# UNITED STATES PATENT AND TRADEMARK OFFICE

APPLICATION NO.	FILING DATE	FIRST NAMED INVENTOR	ATTORNEY DOCKET NO.	CONFIRMATION NO.
10/710,761	08/01/2004	Kun-Chih Wang	NAUP0582USA	4760
27765	7590	10/02/2006	EXAMINER	
NORTH AMERICA INTELLECTUAL PROPERTY CORPORATION P.O. BOX 506 MERRIFIELD, VA 22116			KARIMY, MOHAMMAD TIMOR	
			ART UNIT	PAPER NUMBER
			2815

**Office Action Summary**

## **DETAILED ACTION**

FIG. 3

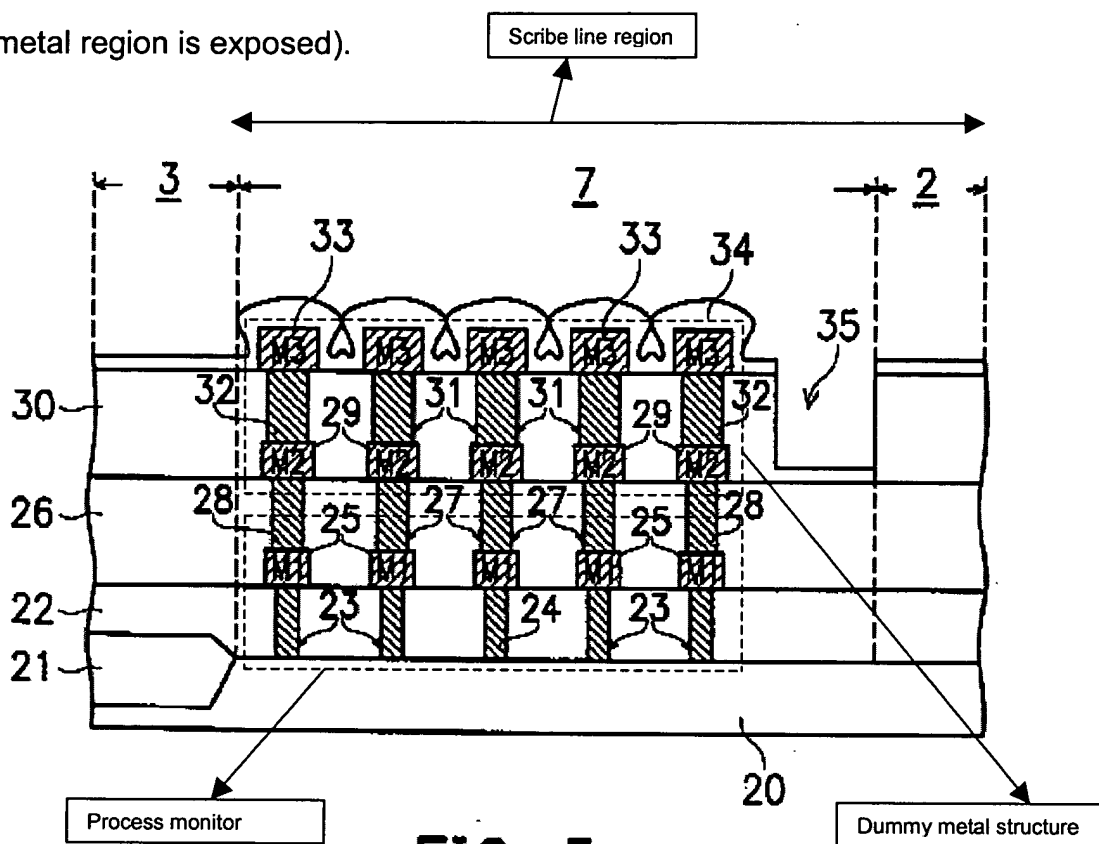
With respect to claim 1, Chang discloses in figures 3-7, a scribe line structure, comprising:

a substrate 20;

a plurality of dielectric layers (22, 26 and 30) formed on the surface of the substrate 20 comprising a structure which would read on the claimed process monitor pattern since the metallic structure 24 & 23, M1, 25 and 27 could function as a structure to monitor metal deposition process.

Chang further teaches a dummy metal structure (M3, figure 3) formed on the surface of the substrate 20 connecting with the process monitor pattern and exposed in

the scribe line region (note that prior to the deposition of the protection layer 34, the dummy metal region is exposed).

With respect to claim 3, Chang discloses the scribe line structure of claim 1 wherein the dummy metal structure (see fig. 3 above) comprises a plurality of dummy vias (note the vias in the dummy metal region in fig. 3 above).

With respect to claim 4, Chang discloses the scribe line structure of claim 1 wherein the dummy metal structure comprises a plurality of metal layers (see fig. 3 above).

With respect to claim 7, Chang discloses the scribe line structure of claim 1 wherein the surface of the substrate further comprises a protective layer 34 covering two sides of the surface of dielectric within the scribe line region (see figure 3).

With respect to claim 8, Chang discloses a scribe line structure comprising:  
a substrate 20, the surface of the substrate comprising at least a scribe line region (see figure 3);

a plurality of dielectric layers (22, 26 and 30) formed on the surface of the substrate 20 comprising a structure which would read on the claimed process monitor pattern since the metallic structure 24 & 23, M1, 25 and 27 could function as a structure to monitor metal deposition process.

Chang further teaches a heat irradiative structure (dummy metal structure – see fig. 3 above) formed in the plurality of dielectric layers (22, 26 and 30) connecting the plurality of dielectric layers with the surface of the substrate and exposed in the scribe line region (note that prior to the deposition of the protection layer 34, the dummy metal region was exposed).

With respect to claim 13, Chang discloses the scribe line structure of claim 8 wherein the heat irradiative structure (dummy metal region, see figure 3) connects with the process monitor pattern (see figure 3 above).
